POWER DISTRIBUTION LIMITS

3/4.2.6 POWER/FLOW INSTABILITY

3/4.2.7 STABILITY MONITORING - TWO LOOP OPERATION

3/4.2.8 STABILITY MONITORING - SINGLE LOOP OPERATION

Operating Region Limits of Specification 3.2.6
Figure 3.2.6-1

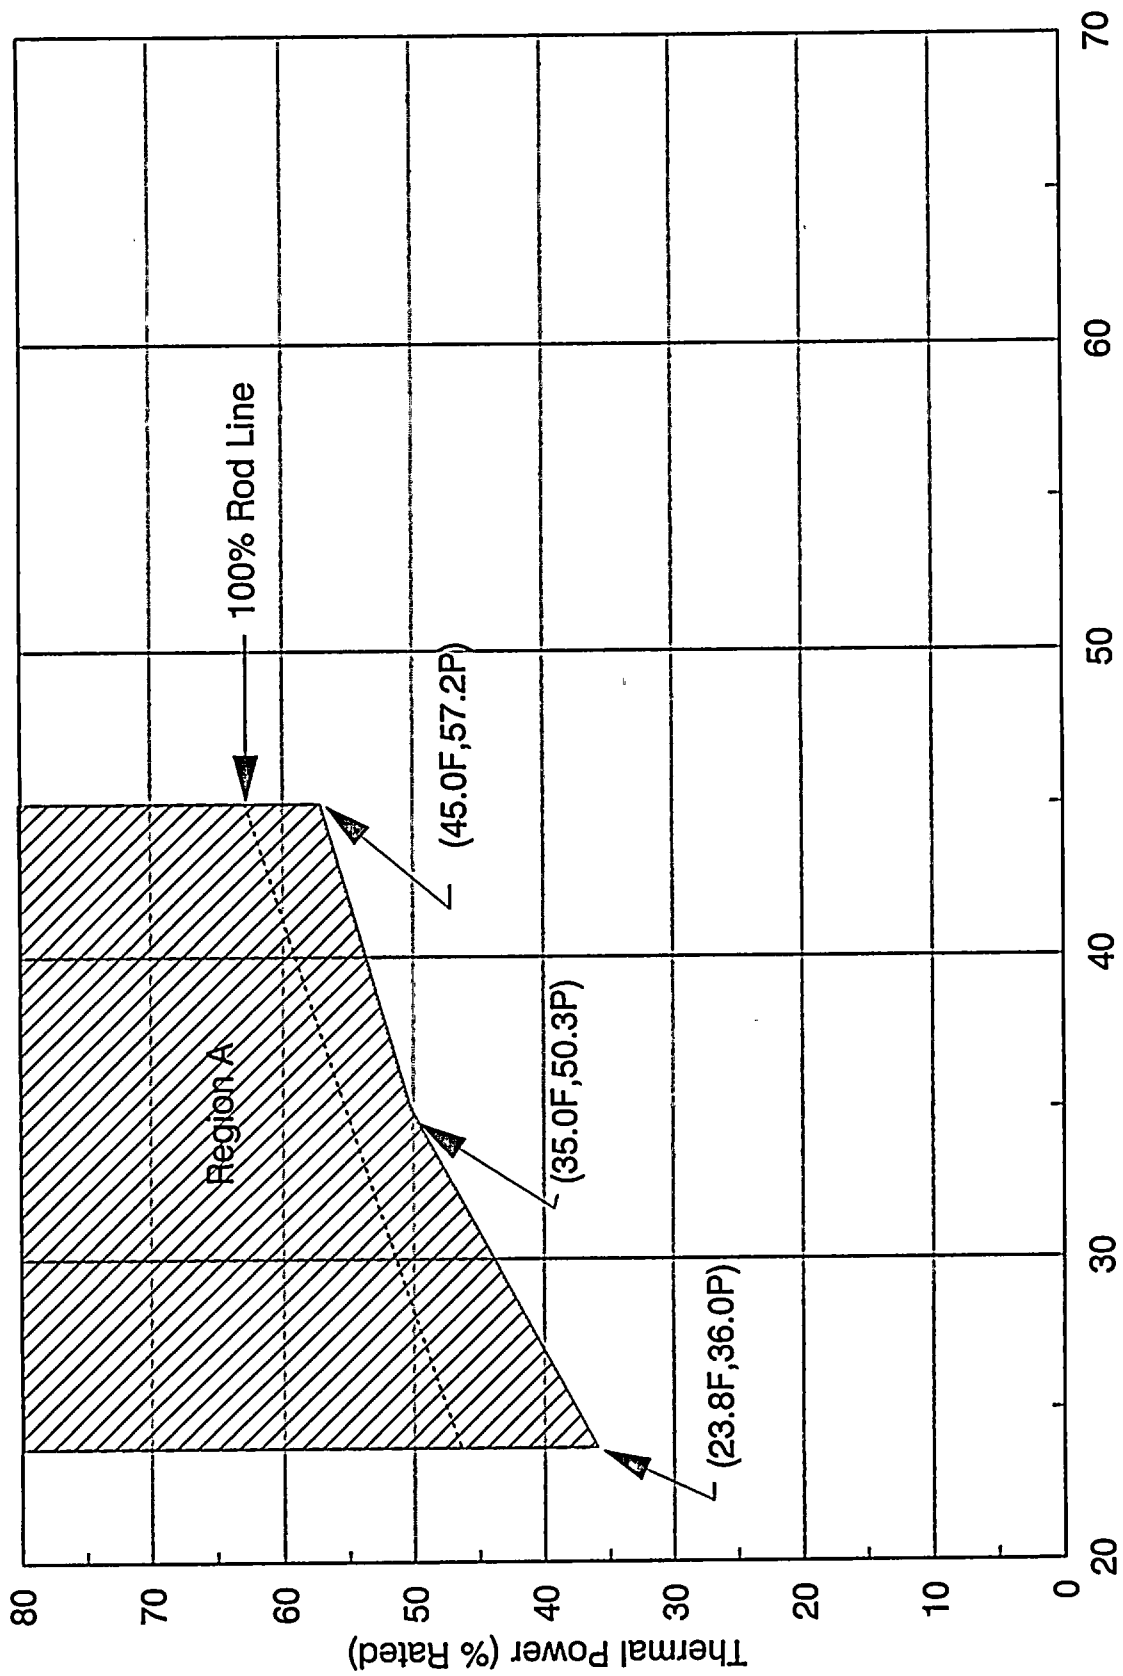
3.2.6 Operation with THERMAL POWER/core flow conditions which lay in Region A of Figure 3.2.6-1 is prohibited.

36% APPLICABILITY: OPERATIONAL CONDITION 1, when THERMAL POWER is greater than ~~39%~~ of RATED THERMAL POWER and core flow is less than or equal to 45% of rated core flow.

REPLACE

Recent calculations by Siemens show that although COTRAN calculates the 0.9 decay ratio line to be above the 100% rod line, the STAIF stability code calculates the 0.9 decay ratio as below the 100% rod line at core flows less than 30%. Therefore, Region A has been expanded. Region A is above the line between a point at 36% power and 23.8% flow and a point at 50.3% power and 35% flow and for core flows greater than 35% the region is bounded by the 91% rod line. Region C is bounded by the 75% rod line.

Operating Region Limits of Specification 3.2.7
Figure 3.2.7-1

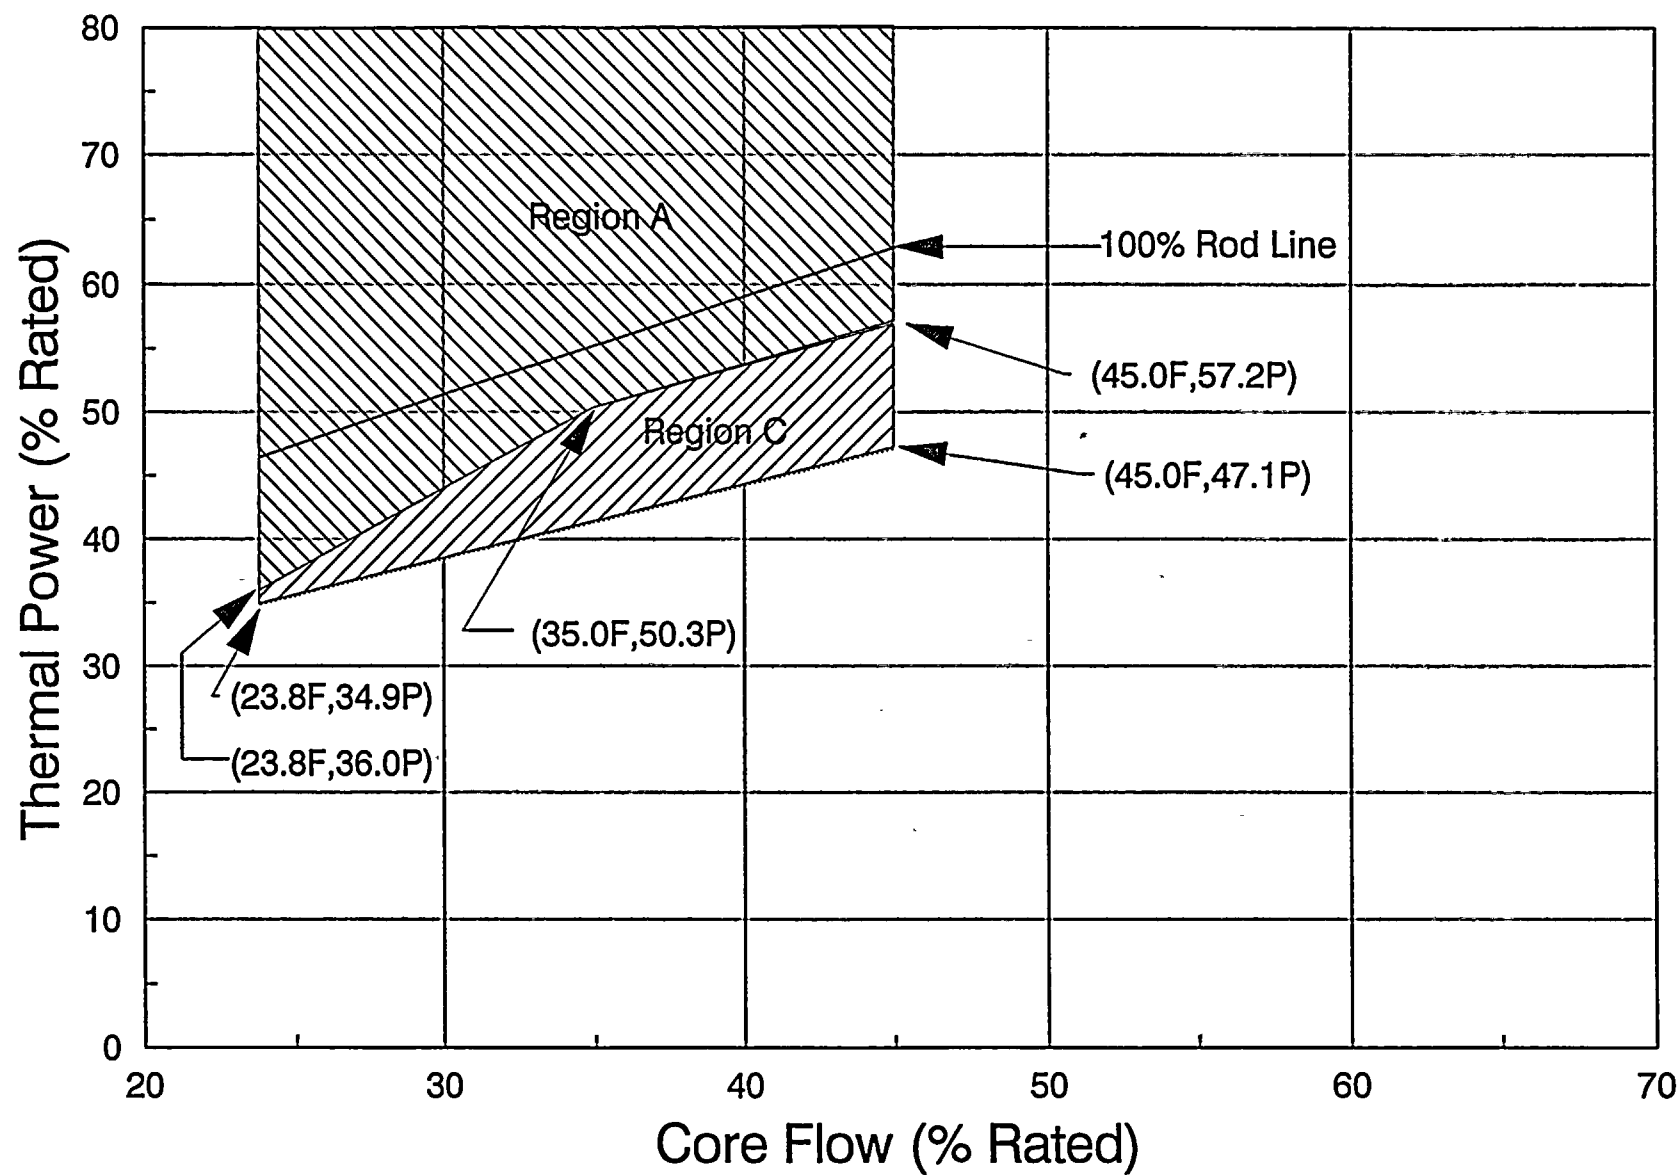
APPLICABILITY: OPERATIONAL CONDITION 1, with two recirculation loops in operation and THERMAL POWER/core flow conditions which lay in Region C of Figure 3.2.7-1.

- a. With decay ratios of any two (2) neutron signals greater than ^{or equal to 0.75} ~~0.75~~ or with two (2) consecutive decay ratios on any single neutron signal greater than ~~0.75~~ ^{or equal to 0.75}:

REPLACE

Stability tests at operating BWRs were reviewed to determine a generic region of the power/flow map in which surveillance of neutron flux noise levels should be performed. A conservative decay ratio of 0.75 was chosen as the basis for determining the generic region for surveillance to account for the plant to plant variability of decay ratio with core and fuel designs. This generic region has been determined to correspond to a core flow of less than or equal to 45% of rated core flow and a thermal power greater than that corresponding to the ~~80%~~ rodline.

^{75%}
Stability monitoring is performed utilizing the ANNA system. The system shall be used to monitor APRM and LPRM signal decay ratio and peak-to-peak noise values when operating in the region of concern. A minimum number of LPRM and APRM signals are required to be monitored in order to assure that both global (in-phase) and regional (out-of-phase) oscillations are detectable. Decay ratios are calculated from 30 seconds worth of data at a sample rate of 10 samples/second. This sample interval results in some inaccuracy in the decay ratio calculation, but provides rapid update in decay ratio data. A decay ratio of 0.75 is selected as a decay ratio limit for operator response such that sufficient margin to an instability occurrence is maintained. When operating in the region of applicability, decay ratio and peak-to-peak information shall be continuously calculated and displayed. A surveillance requirement to continuously monitor decay ratio and peak-to-peak noise values ensures rapid response such that changes in core conditions do not result in approaching a point of instability.

Operating Region Limits of Specification 3.2.8
Figure 3.2.8-1

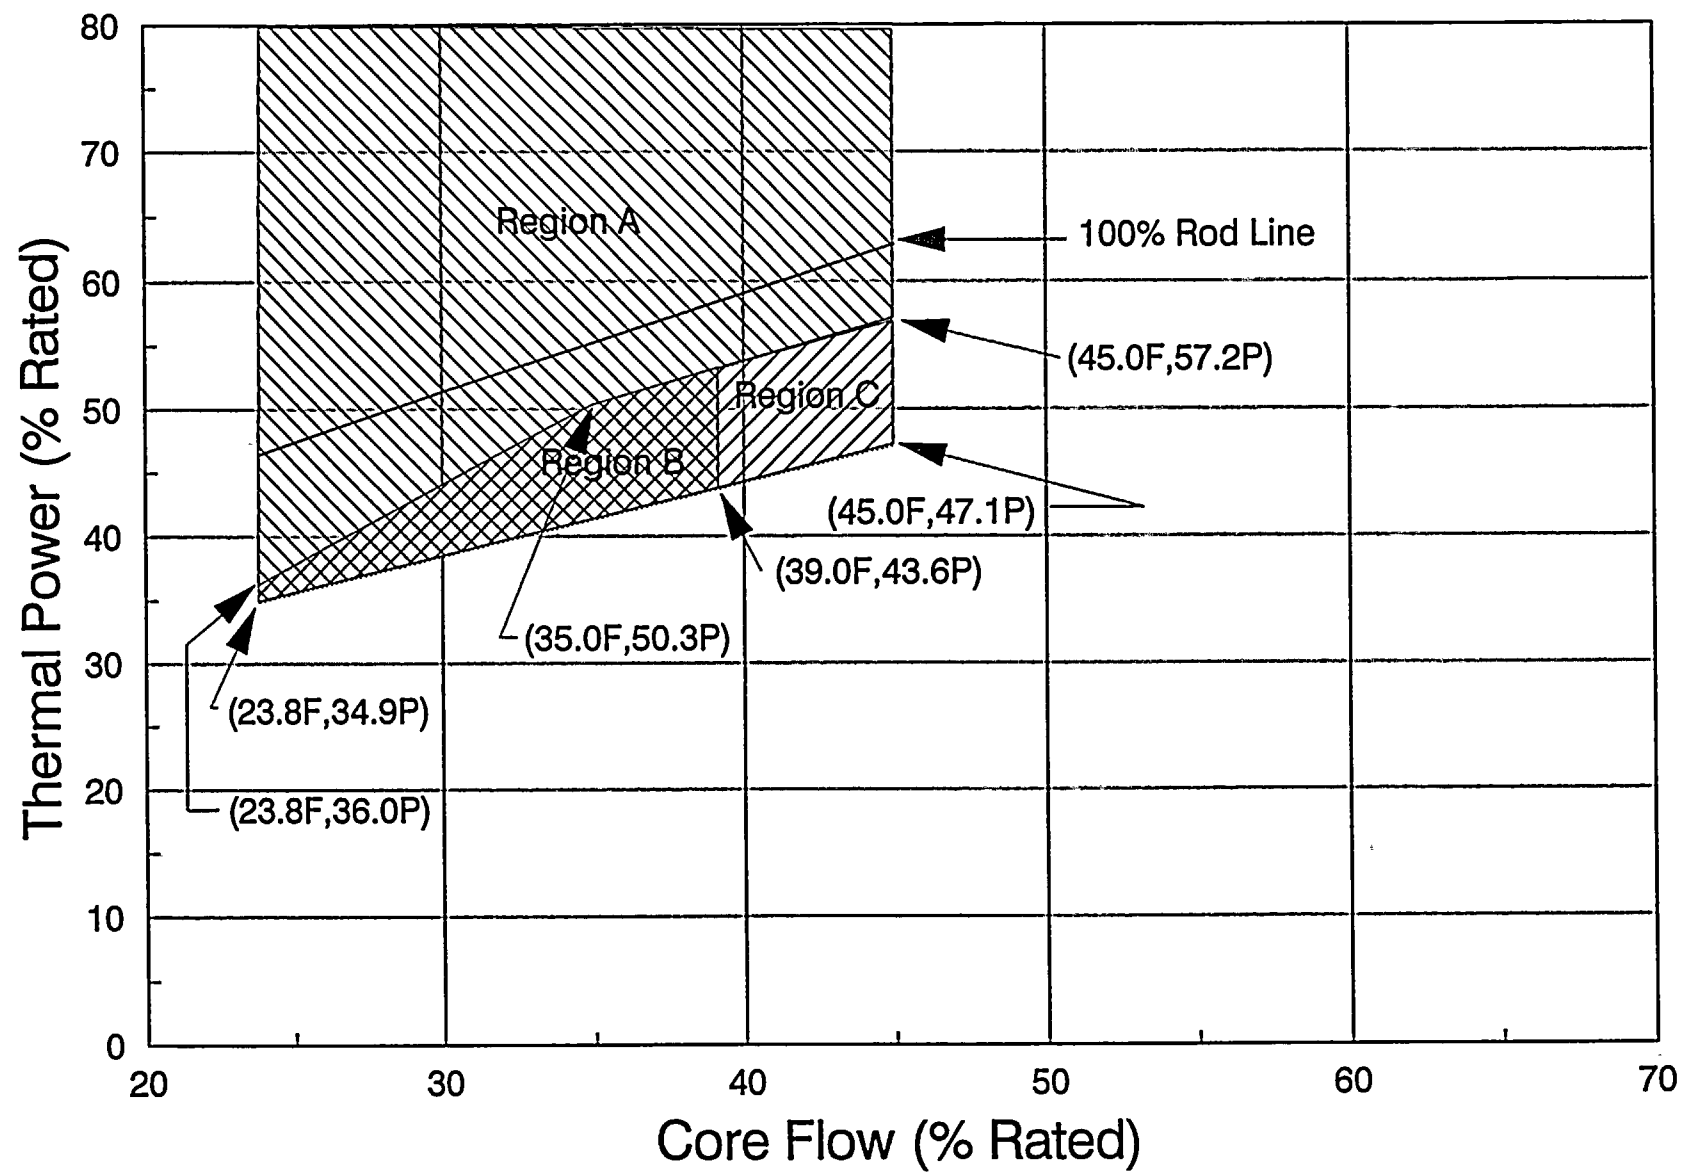
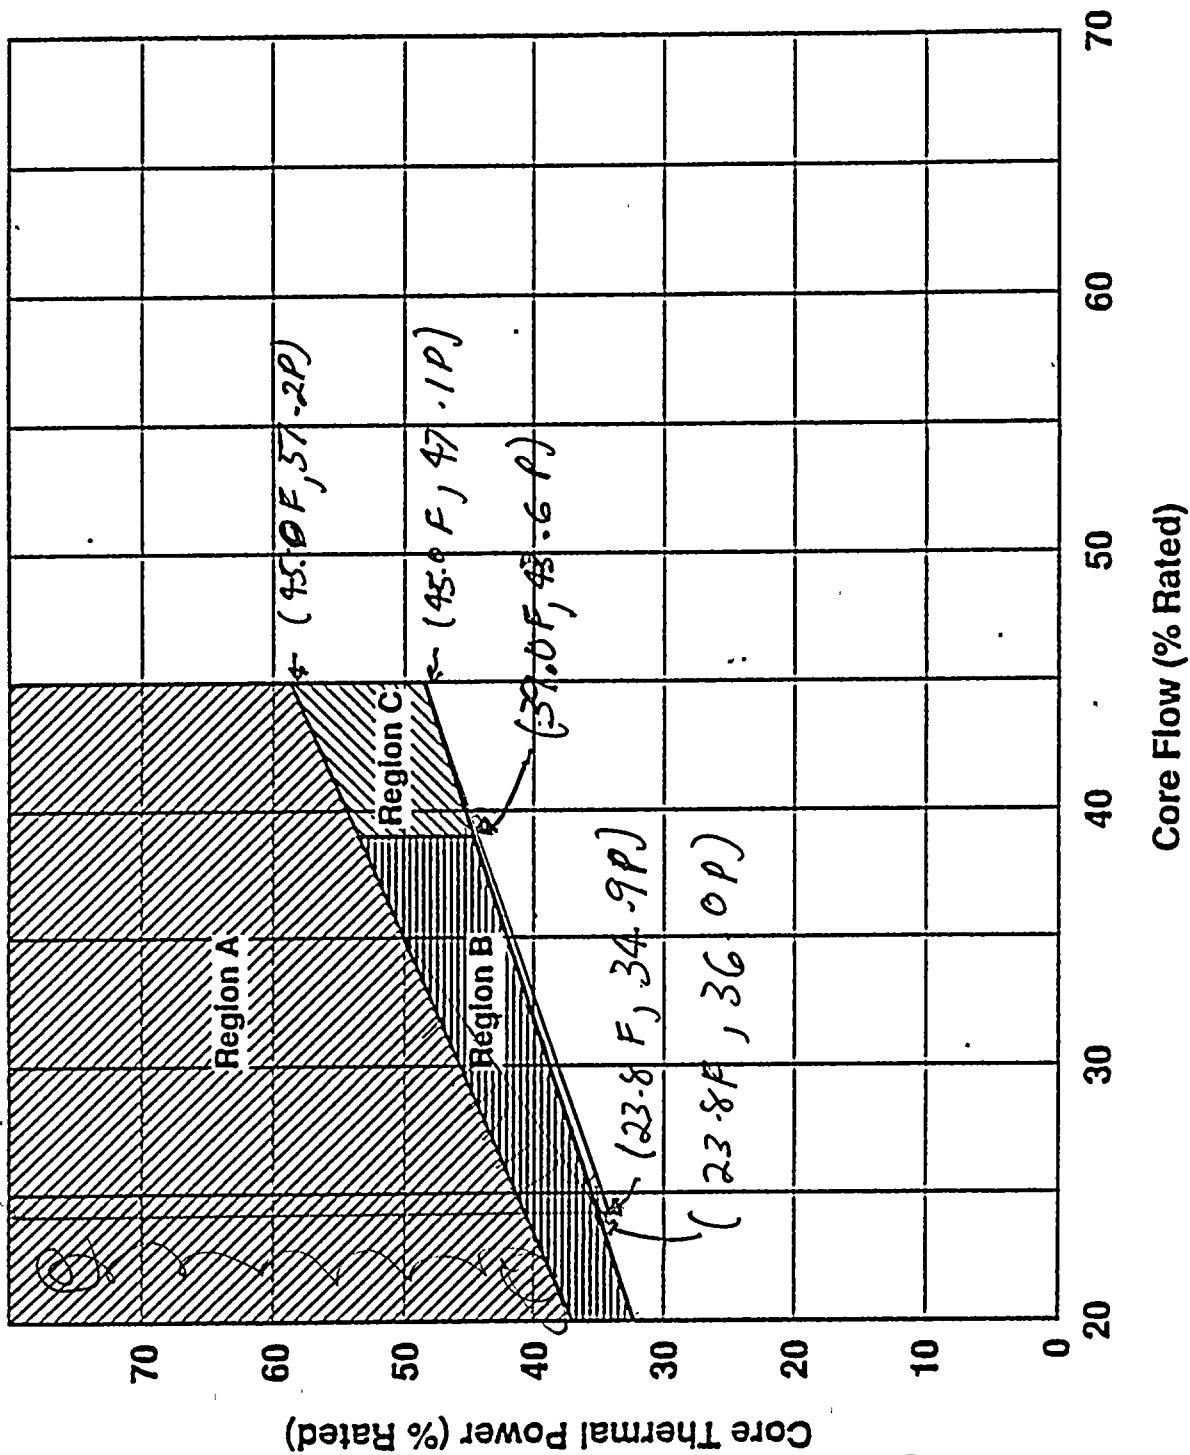
APPLICABILITY: OPERATIONAL CONDITION 1, with one recirculation loop in operation and THERMAL POWER/core flow conditions which lay in Region C of Figure 3.2.8-1.

- a. With decay ratios of any two (2) neutron signals greater than ^{or equal to 0.75} 0.75 or with two (2) consecutive decay ratios on any single neutron signal greater than ^{or equal to 0.75} 0.75:

REPLACE

The basis for stability monitoring during single loop operation is consistent with that given above for two loop operation. The smaller size of the region of allowable operation, Region C, is due to a limit on the allowed flow above the ~~80%~~ rodline. When operating above the ~~80%~~ rodline in single loop operation, the core flow is required to be greater than 39%.

^{75%}

Operating Region Limits of Specification 3.4.1.1
Figure 3.4.1.1-1

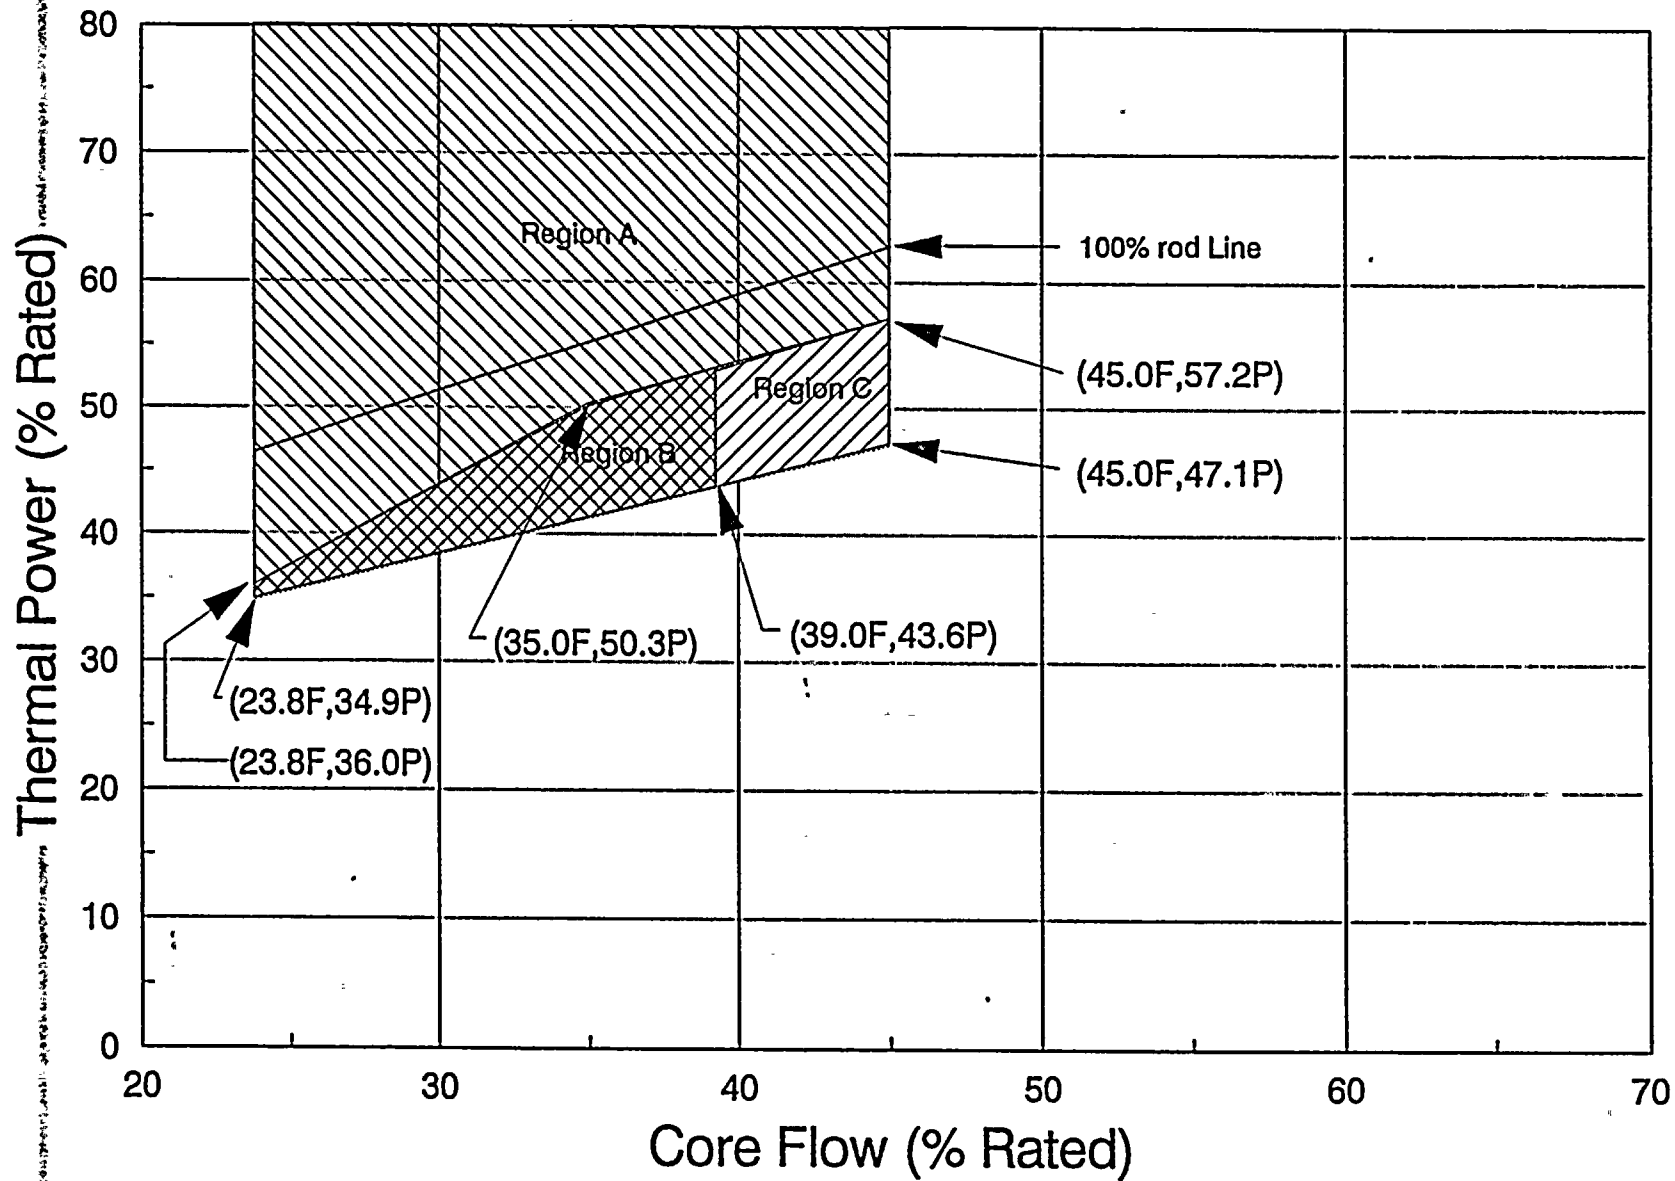
REPLACE
